TOWN OF LOS GATOS
PLANNING COMMISSION AGENDA
JANUARY 13, 2021
110 EAST MAIN STREET
LOS GATOS, CA

The applicant has revised the development plans in response to the comments received from the Planning Commission and provided a summary of the revisions to the development plans (Exhibit 18). The revised development plans include two alternatives, a Mediterranean/Spanish style (Exhibit 20) and a Craftsman style (Exhibit 21). The materials proposed for the Mediterranean style include stucco walls, and clay tile roof. The materials proposed for the Craftsman style include stucco or paint grade siding for the first floor, stained wood siding for the second floor, and composition shingle roof. Both style alternatives include wood windows and doors. The two style alternatives both reduce the overall height from 27 feet to 24 feet 10

In response to the letter (Exhibit 19) from Mr. Lyon sent on January 2, 2021, on behalf of the neighbors, the applicant has made additional revisions to the Craftsman style alternative. The applicant's response to the neighbor comments is included in Exhibit 18, and a revised set of development plans, the "Revised Craftsman Proposal," was submitted on January

1 FRONT ELEVATION @ LOMA ALTA AVE.

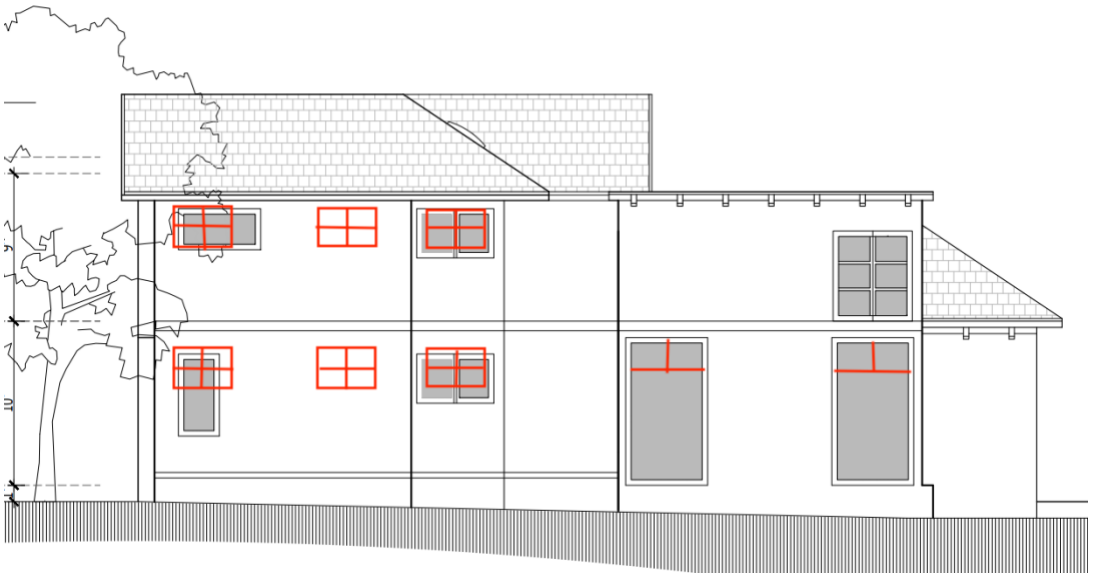
1. Consistent lighting on doors and windows: The color renderings (sheet 3.4) has consistent lighting (preferred) on the Front and Panighetti Place elevation, while the line drawings (sheet A3.1a) do not (redlines capture the renderings)

2. Sheet A3.1a calls out a Plexiglass railing – I believe this is a remanent of the prior design and should be eliminate for the exterior elevations.
   Is removed in the new set.
3. The Side Elevation fenestration is awkward and inconsistent with the Craftsman motif. A more consistent fenestration would be a multi-lighted high awning window to provide light and privacy to the two bedrooms and bathrooms. Further, some level of Craftsman lighting details at the top of the large view windows would tie them into the overall design.

4 SIDE ELEVATION

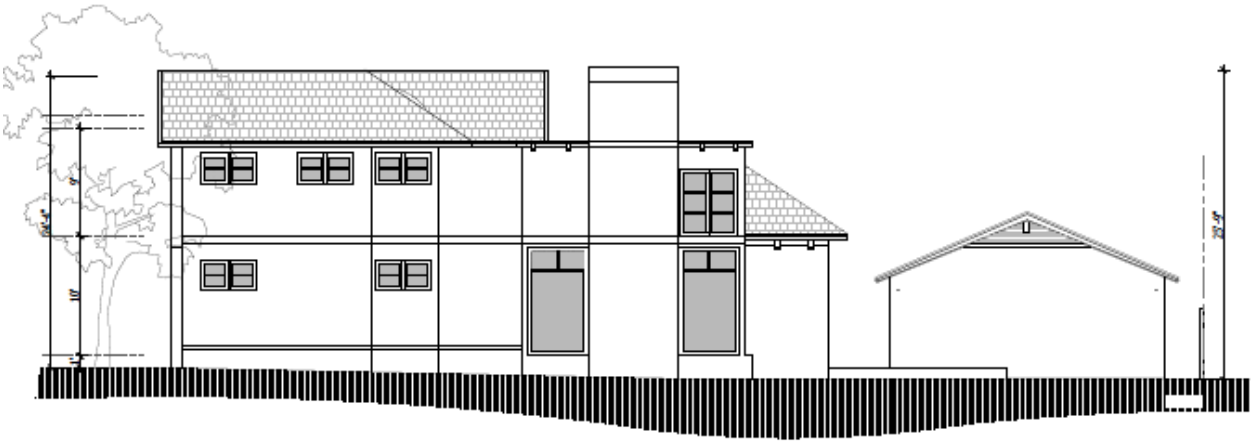
4. There are inconsistencies between the floor plans and elevations. As example - the floor plan (living room) and front elevation shows a chimney, but the chimney is not shown on the side elevation.
   Is addressed in the new plan set.
5. The sloped roof overhangs are inconsistent depth. The Side Elevation overhang is much larger (2'10" from the roof plan or greater based on wall articulation) than any other overhang and appears quite awkward.
   They are consistent now.

The side elevation in the new plan set include all of these recommendations, except the additional window in first floor bedroom. It goes to the closet of that room.

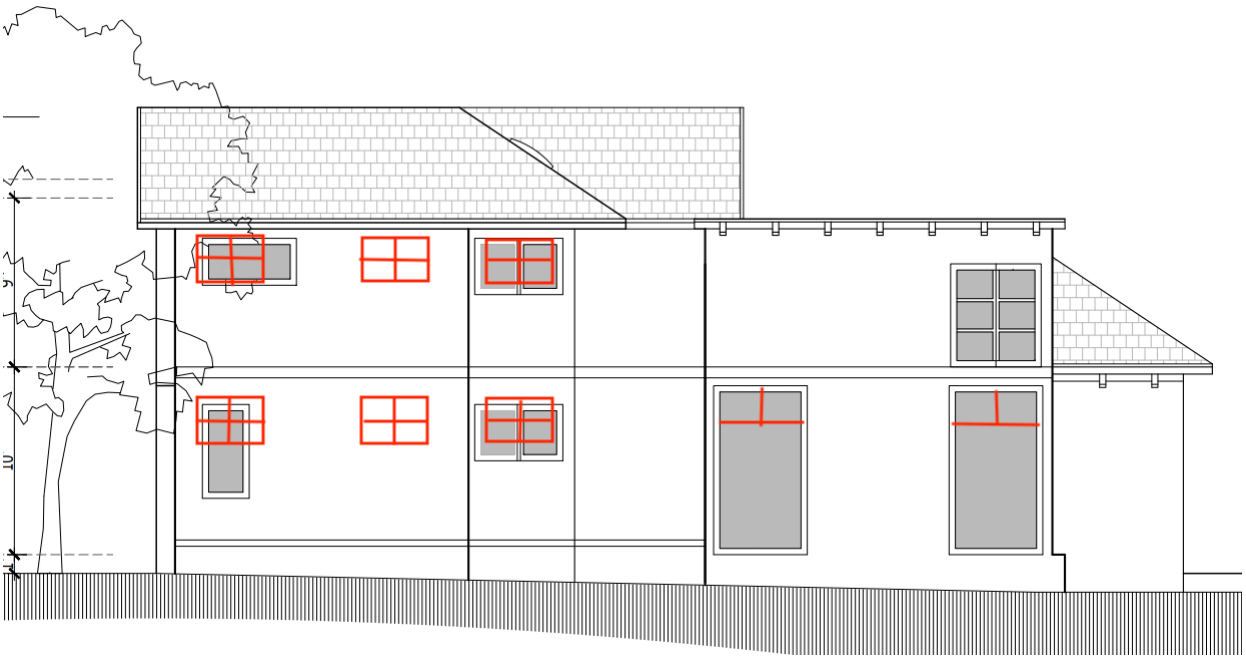
1. Consistent lighting on doors and windows: The color renderings (sheet 3.4) has consistent lighting (preferred) on the Front and Panighetti Place elevation, while the line drawings (sheet A3.1a) do not (redlines capture the renderings)

2. Sheet A3.1a calls out a Plexiglass railing – I believe this is a remanent of the prior design and should be eliminate for the exterior elevations.
3. The Side Elevation fenestration is awkward and inconsistent with the Craftsman motif. A more consistent fenestration would be a multi-lighted high awning window to provide light and privacy to the two bedrooms and bathrooms. Further, some level of Craftsman lighting details at the top of the large view windows would tie them into the overall design.

4. There are inconsistencies between the floor plans and elevations. As example - the floor plan (living room) and front elevation shows a chimney, but the chimney is not shown on the side elevation.
5. The sloped roof overhangs are inconsistent depth. The Side Elevation overhang is much larger (2'10" from the roof plan or greater based on wall articulation) than any other overhang and appears quite awkward.

Overall the design still has inconsistencies that should be addressed by the applicant and the Town Consulting Architect. Thank you for your consideration and I look forward to the Planning Commission including my specifics above as part of the Conditions of Approval.

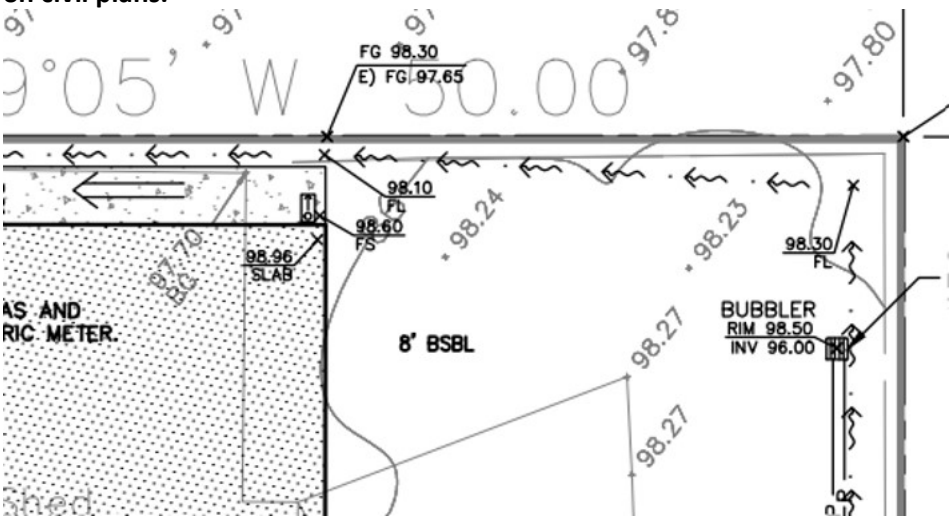
Regards,

James Lyon

Cc: Rick Rutter, Kelly Luoma, Babak Homayouni, Bahar Masarati
